PCN 15_0032:

Alternate fab source for ISO TC start silicon die.
To enable additional wafer fabrication capacity.

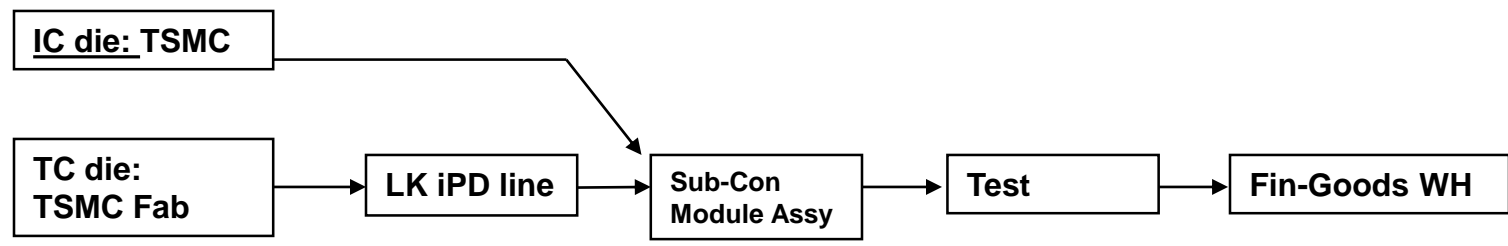
Current Flow:

Alternate Flow:
